PLANNING BOARD REPORT #52-02

**PROP MULTI-FAMILY DEVELOPMENT
ANDERSON STREET
SITE PLAN AND SUBDIVISION REVIEW**

TO: Kandi Talbot – Planner
FROM: Jim Seymour – Development Review Coordinator, Sebago Technics, Inc.
RE: PROP Family Housing – 113 Anderson Street
DATE: July 2, 2002

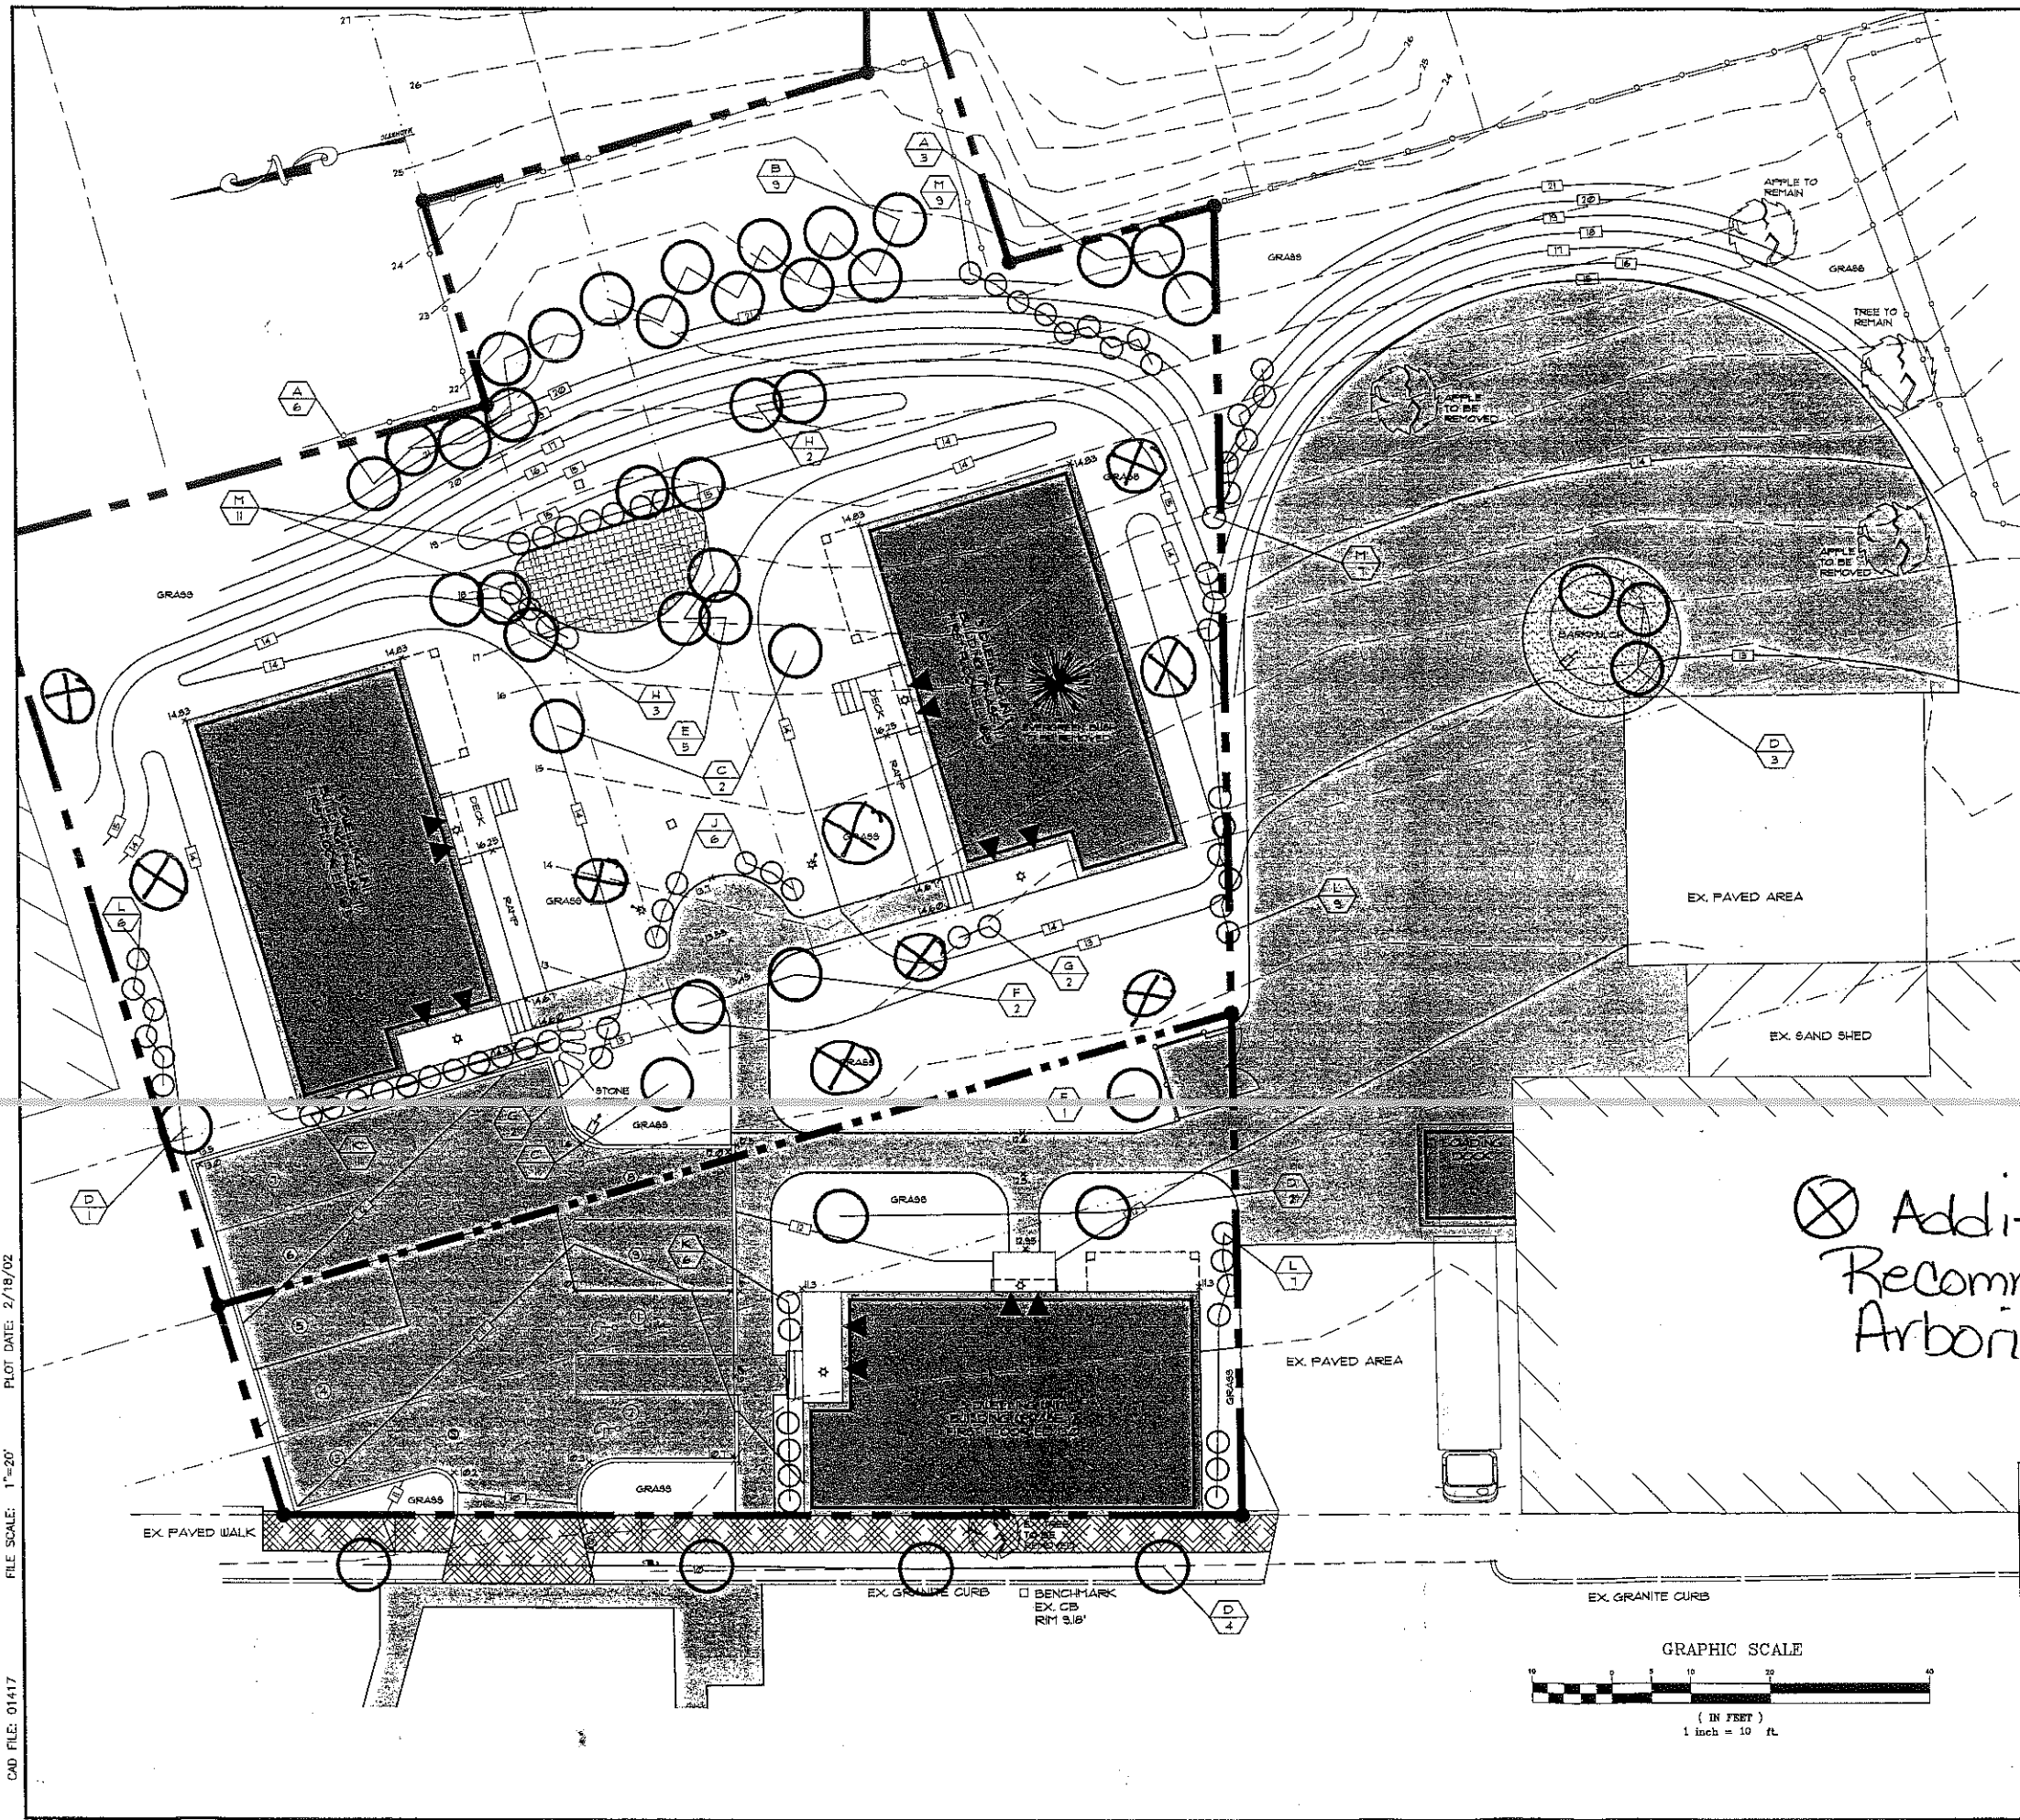
- * The applicant has proposed a dense buffer of Pines on the eastern property line. Normally, this dense buffer would be encouraged, however, because of the grade difference between the abutting Hammond Street property and this property, there is a fear that the area behind the buffer could become a screening for illegal behavior. I am recommending that the applicant reduce the number of trees proposed within this area.
- * I would recommend that the applicant install approximately nine (9) additional shade trees around the two rear buildings. Please see the attached site plan showing the recommended location of the shade trees.
- * I have reviewed the plant list. Based on the Technical and Design Standards and Guidelines the size for the proposed Hemlock should be 5-6 ft. tall and size of the Cornelian Cherry and Flowering Crab should be at least 2 inch caliper.

- That the applicant revise the landscape plan to reflect the City Arborist's memo dated August 9, 2002 for review and approval by the City Arborist.

SITE PLAN APPROVED BY THE
CITY OF PORTLAND PLANNING BOARD

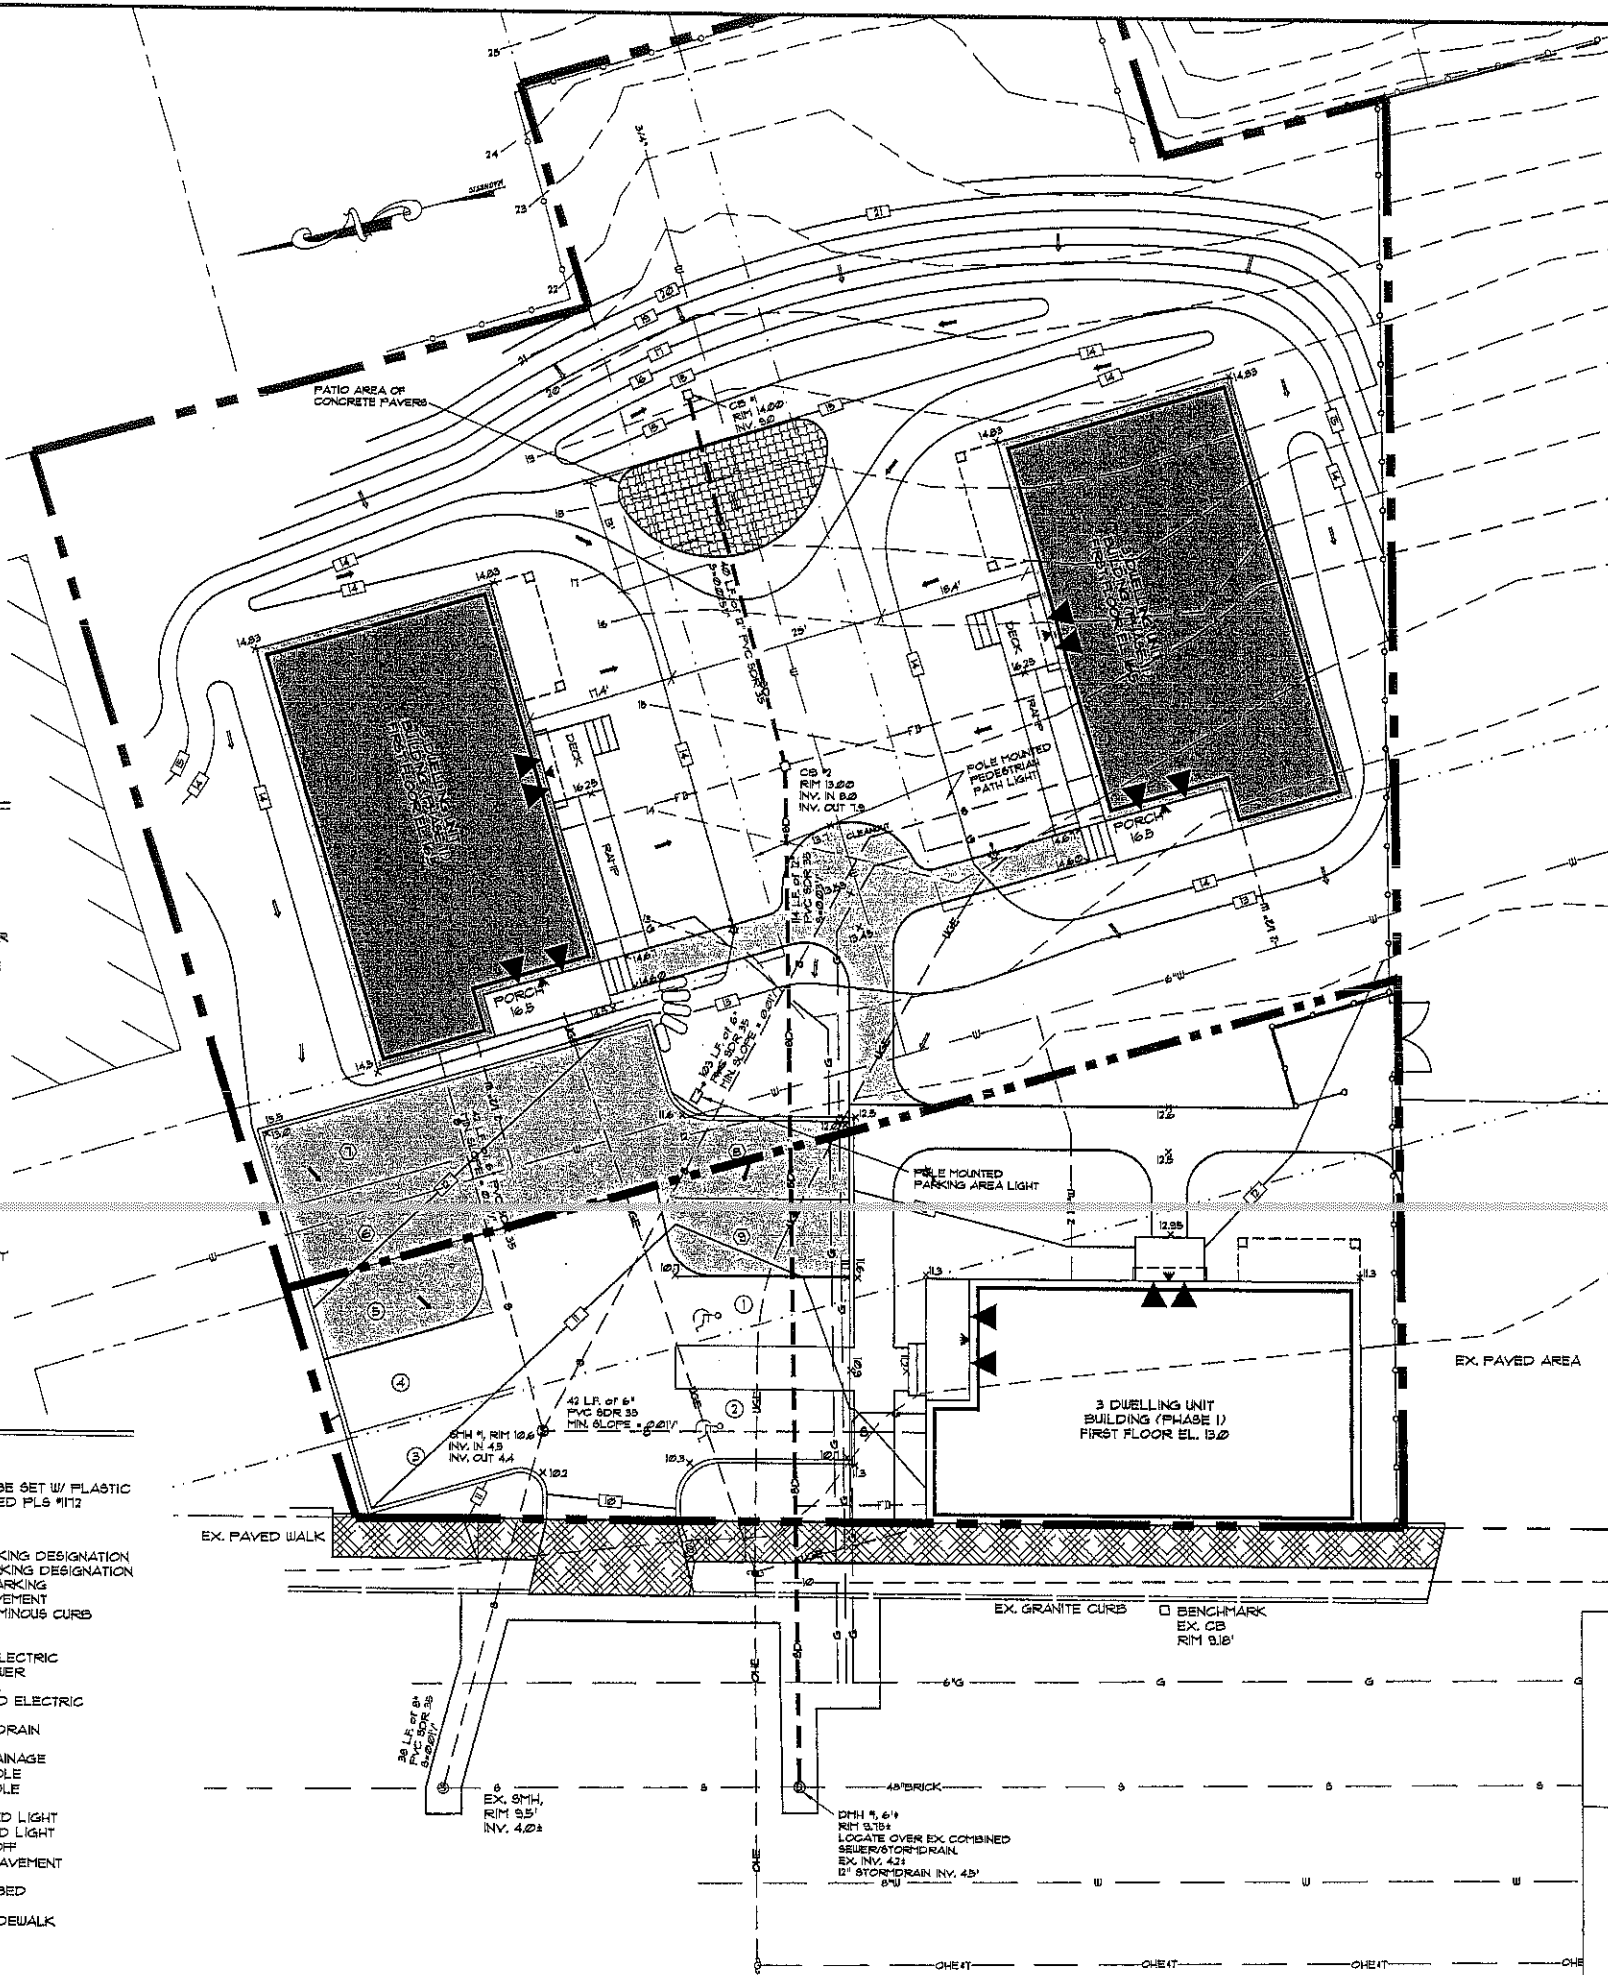
2. As a result of the utility trenches proposed on the plans, the applicant will be required to remove and reset existing granite curb. The "site plan", sheet C2 should specify the quantity and limits of granite curb to be reset.

3 CONCRETE SIDEWALK AND DRIVEWAY CONSTRUCTION NOT TO SCALE

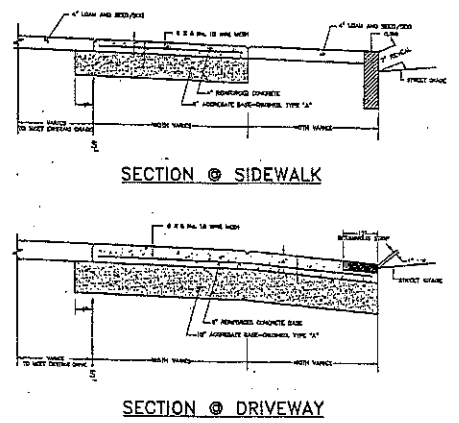
Granite curb currently exists along Anderson Street. The applicant is proposing to install a sidewalk along the frontage of Anderson Street. The applicant should specify a construction detail for concrete sidewalk on the detail sheet.

7 DUMPSTER ENCLOSURE DETAIL NOT TO SCALE

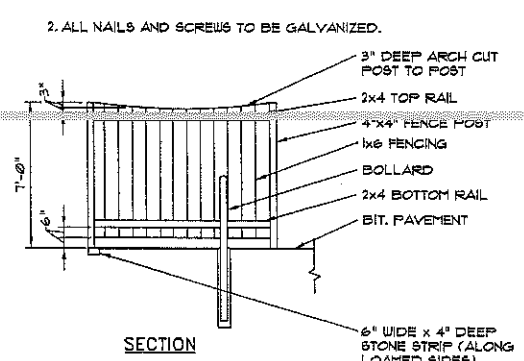
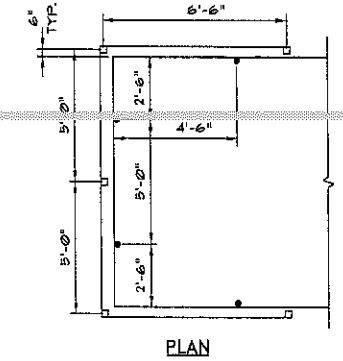
The applicant is providing an enclosed dumpster for solid waste disposal on-site. A detail of the dumpster enclosure will need to be submitted to staff for review. The applicant has explained that the dumpster will be accessed from the northerly side by tenants to dispose of their solid waste and will be accessed from the southerly side by a solid waste contractor to remove the solid waste. Staff is recommending that the applicant provide an easement from Portland Housing Authority allowing them access through the site for solid waste removal.

- A. Two planting details are included as items 8 and 9. Their proposed locations and species should be noted on the appropriate plan.
- B. Dumpster enclosure details are needed.
- C. Erosion control notes, seeding notes and details shall be placed on the plans so that the contractor will have them in the field.
- D. Appropriate BMP details shall be included on detail plan sheet.
